**ADDENDUM NO. 4
TO
SPECIFICATIONS AND CONTRACT DOCUMENTS
FOR
ROAD RESURFACING, REPAIR, AND ASPHALT PAVING
FOR THE
PEACH COUNTY BOARD OF COMMISSIONERS
RFB#22-004**

TPE PROJECT # PCO 059
February 2022

Addendum Issued: April 28, 2022

POWERSVILLE ROAD

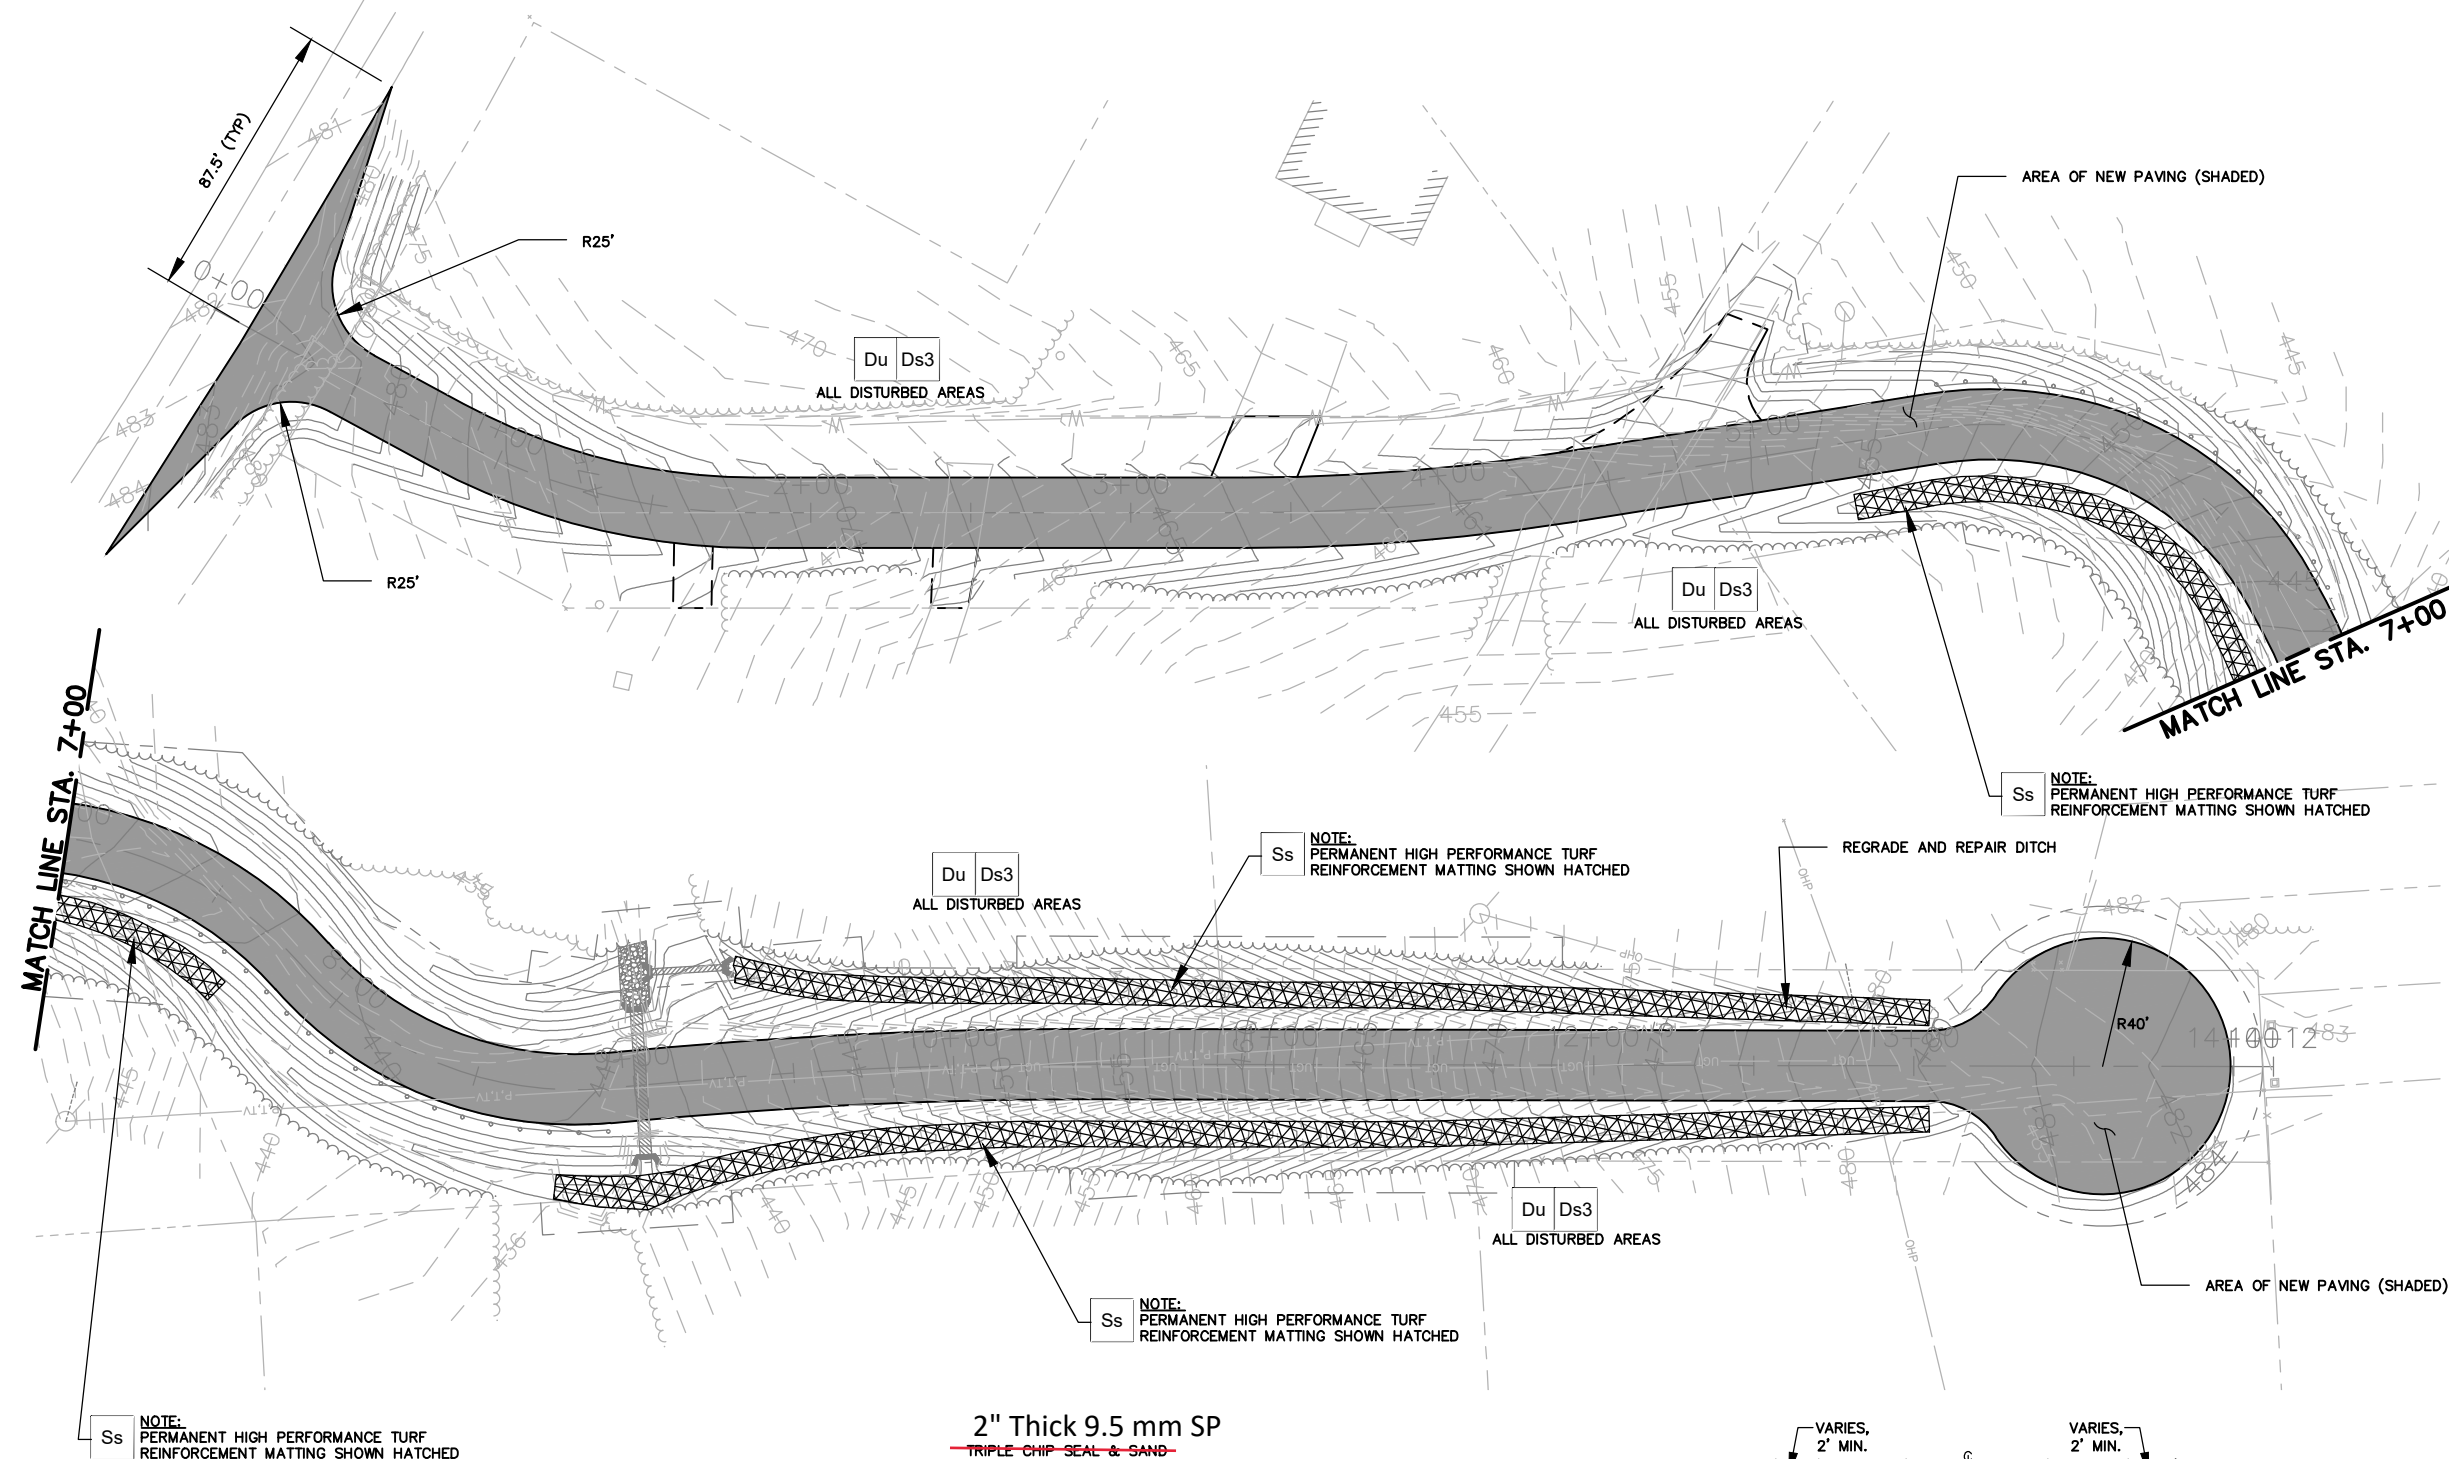
The revision removes any work within the HWY 247C right-of-way. In addition, the revision replaces double surface treatment section with road replacement (pavement removal, 6" GAB, and 2" 9.5 mm SP). Quantity changes are reflected in the revised Bid for Powersville Road.

Hartley Road
1.17 Mi. , Ave width 20.5'
Rebuild Road with 6"/2"

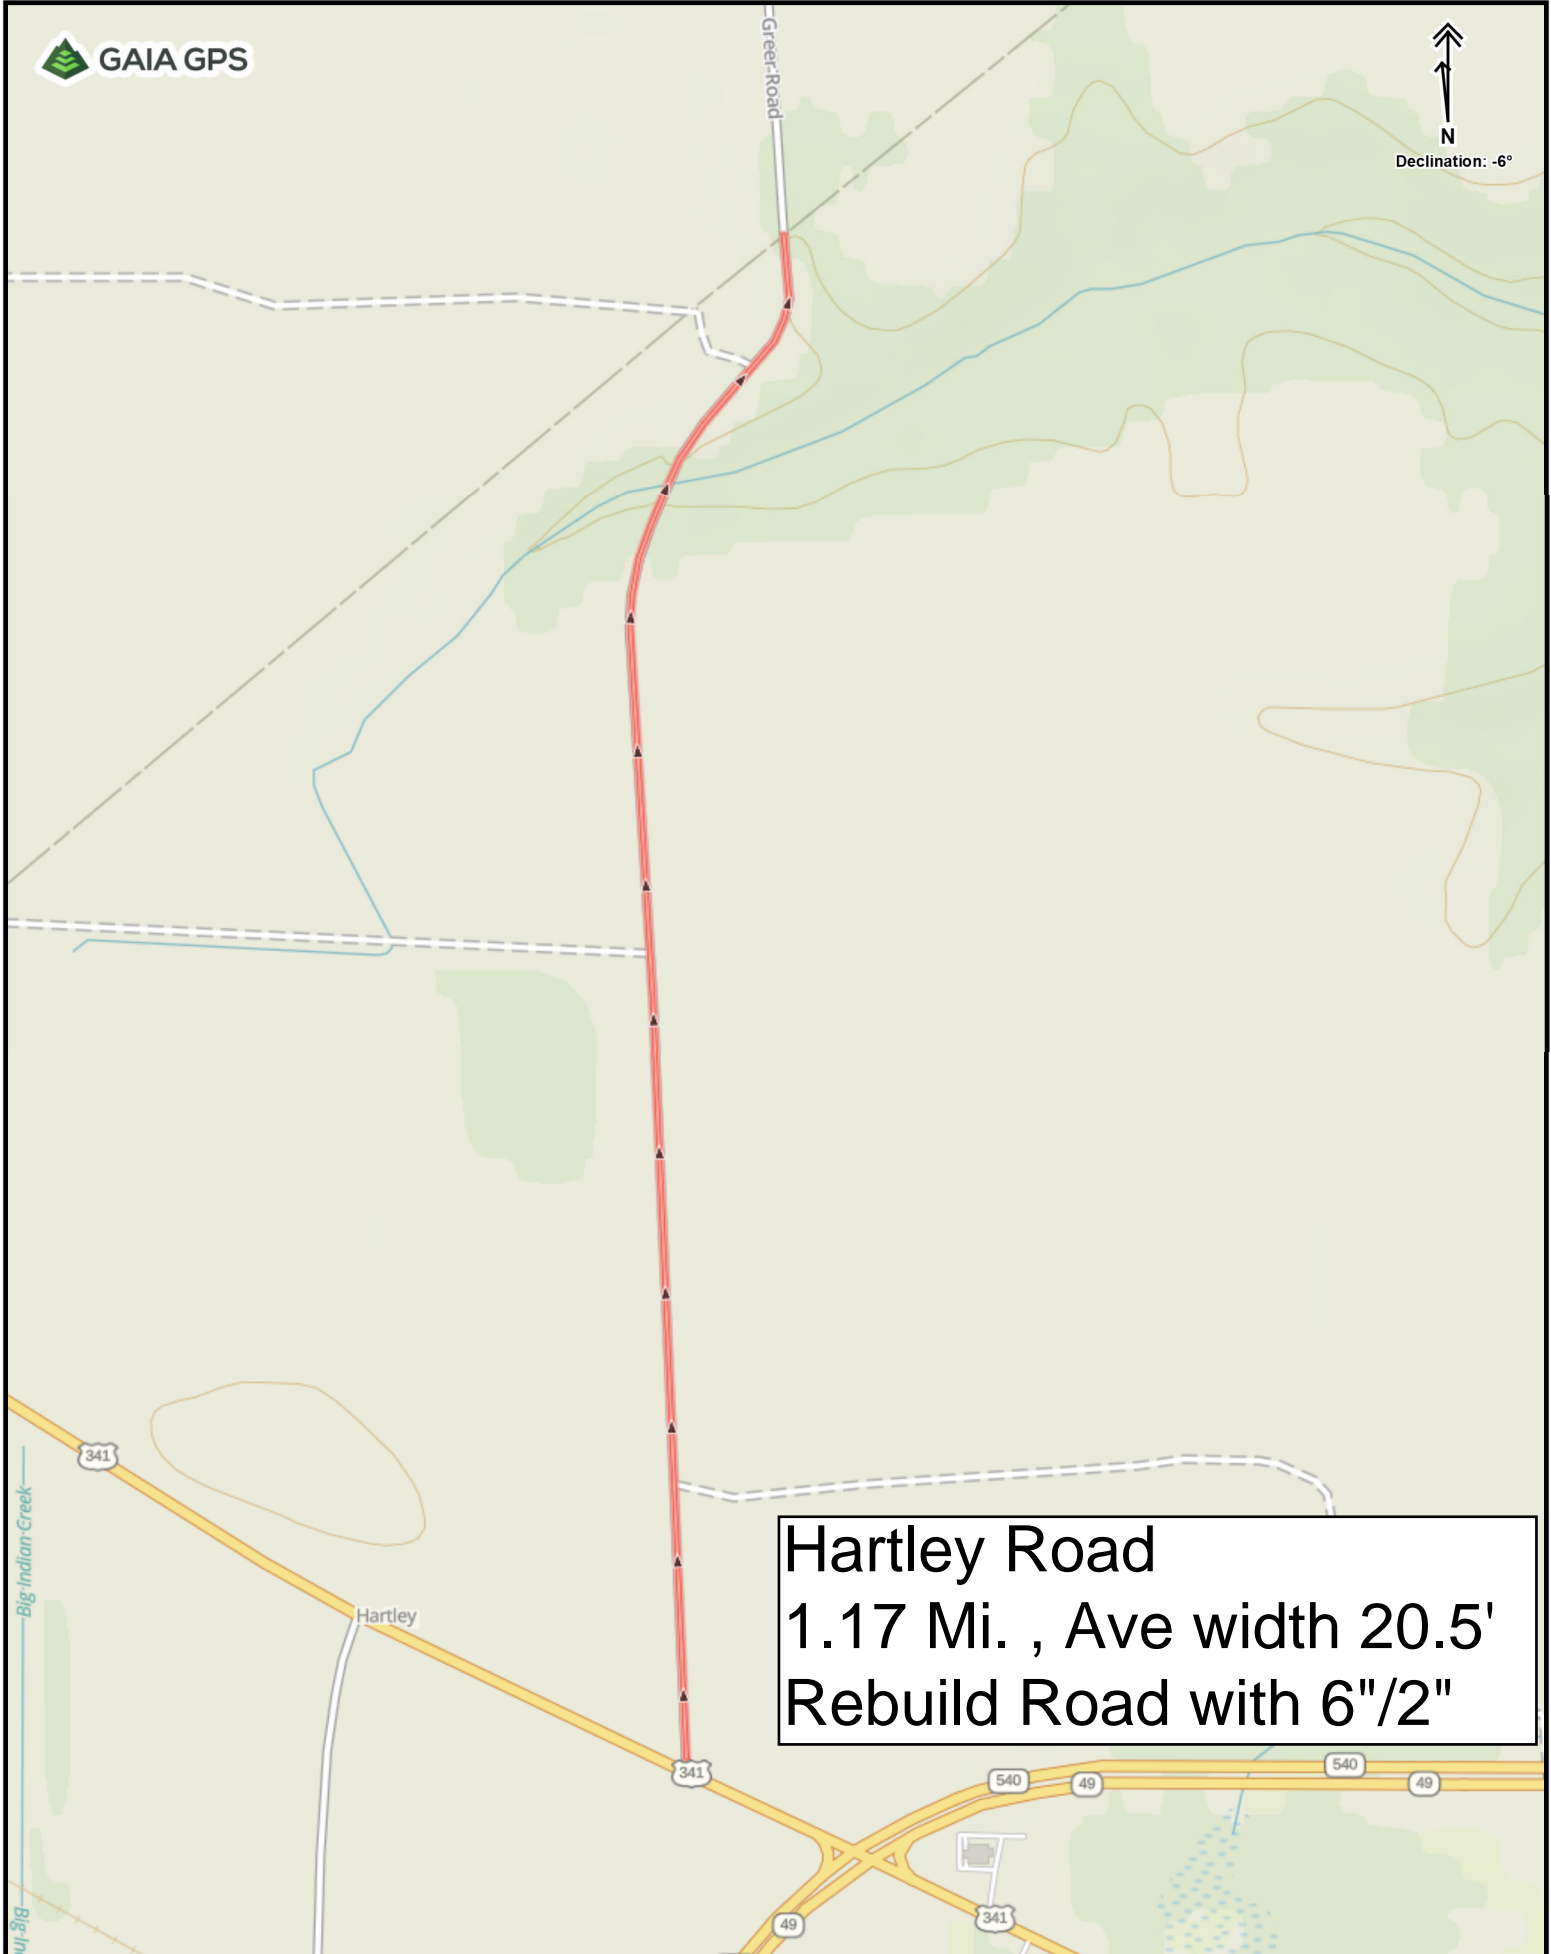
Add: Hartley Road
